ADDENDUM:

1

PROJECT NAME: Glenview Heights Exterior Upgrades

This Addendum is used to Identify Items in the Original Documents with Action as Follows:

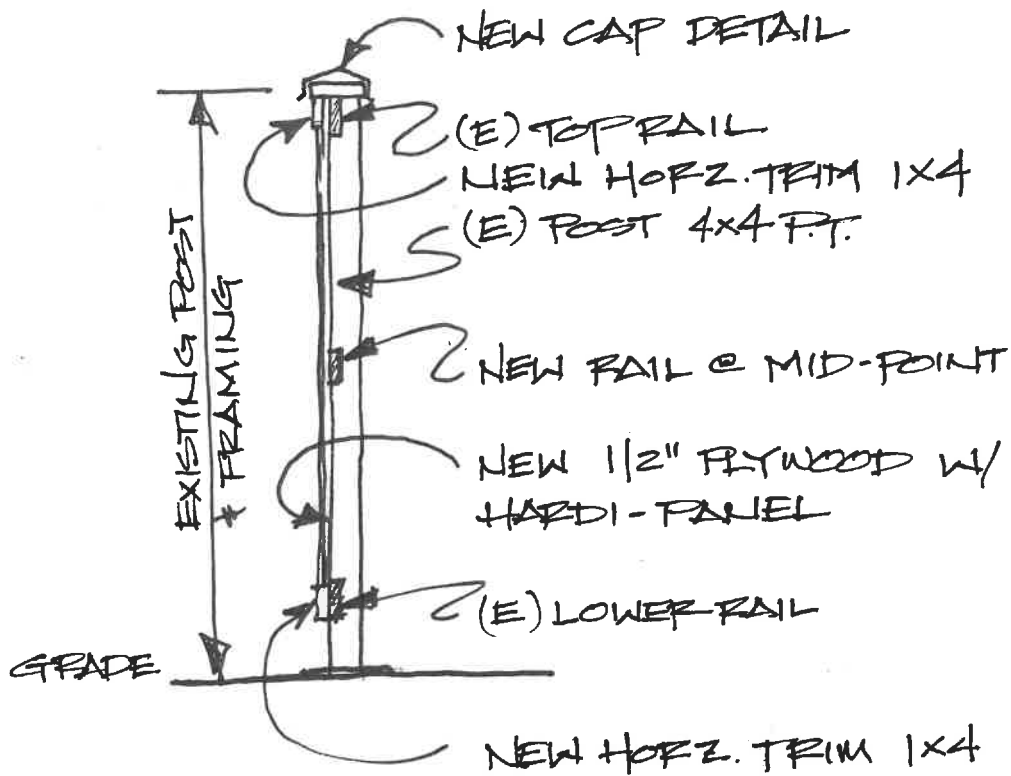
Door 002- (A402 Door Legend #2)

Change door legend with new drawing labeled 002. Add integrated blinds to all 002 doors.

ASK-01

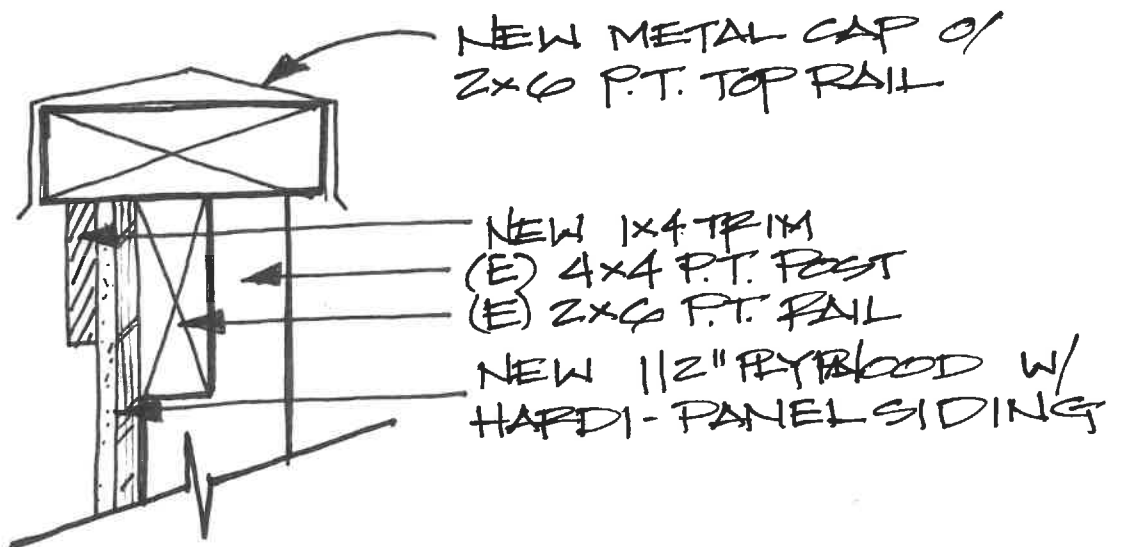
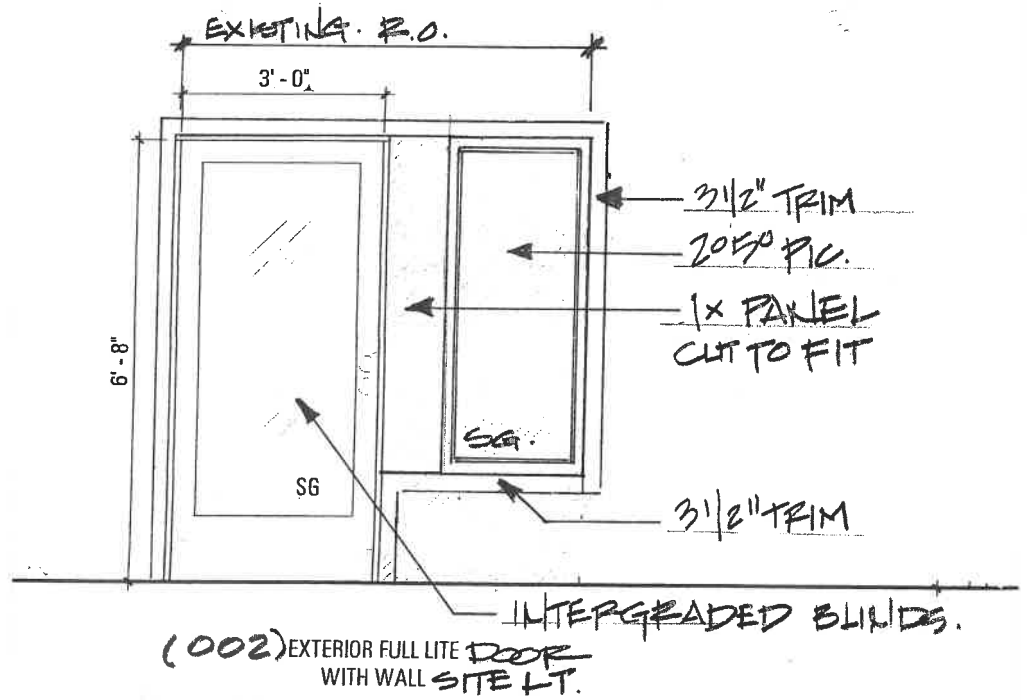
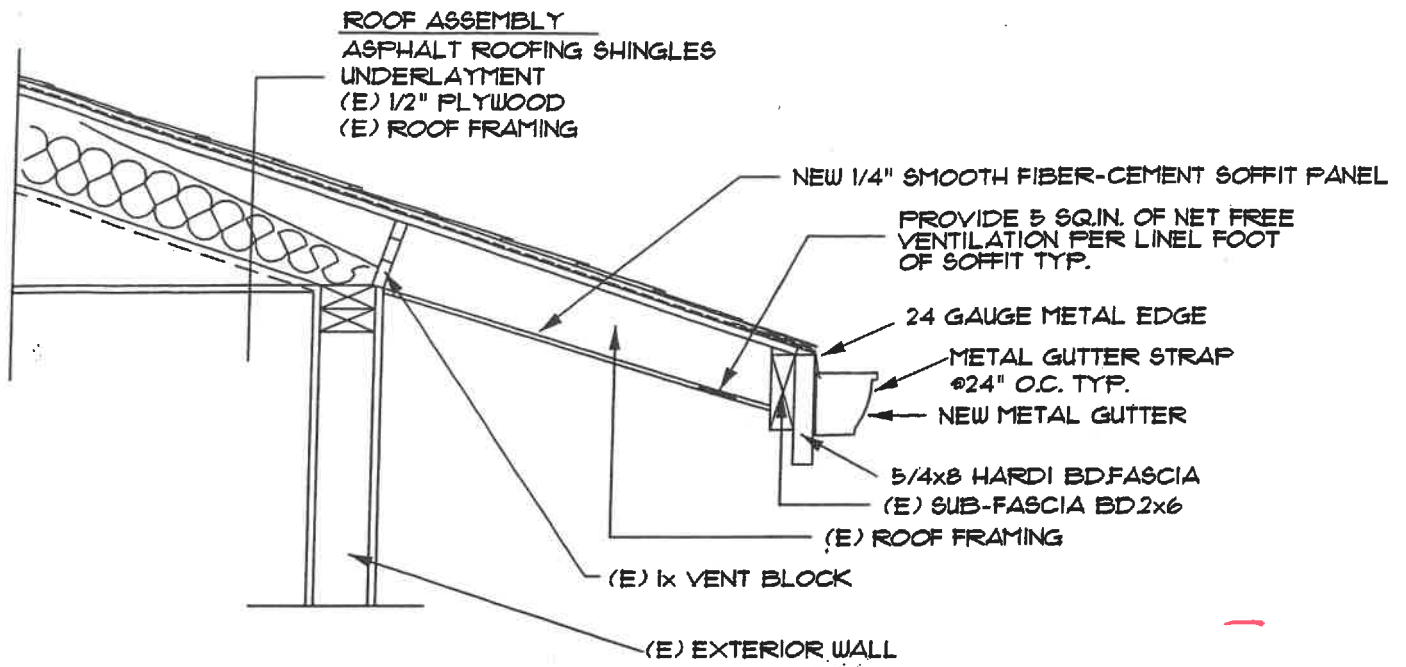
A5/A301 (Privacy Wall) – REPLACE WITH ASK-01 DETAIL

1 ELECTRICAL SITE PLAN
SCALE: 1"= 20'-0"

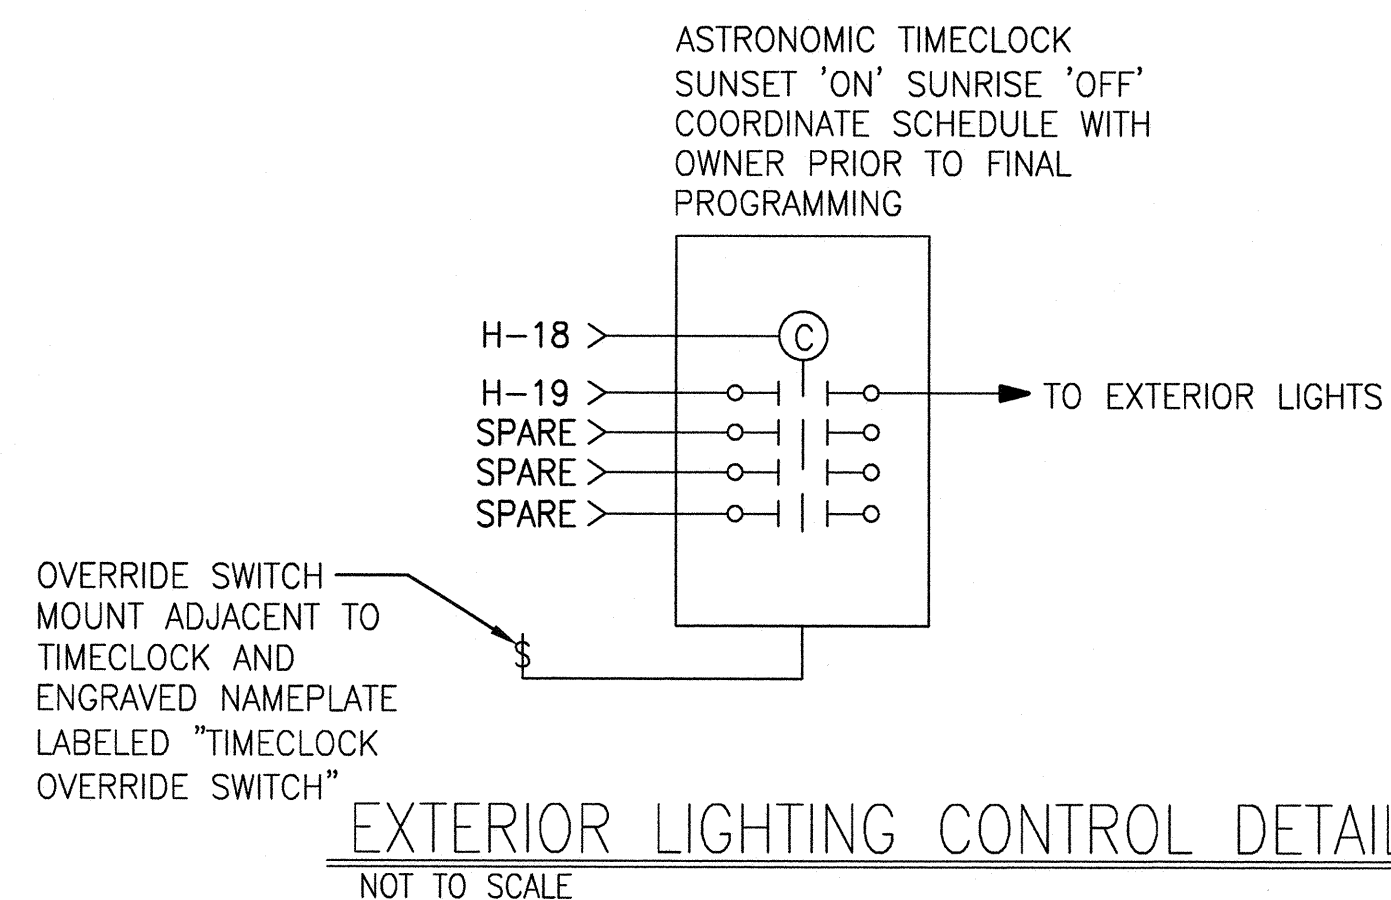
ADD: Electrical Page E001 "For Reference Only"
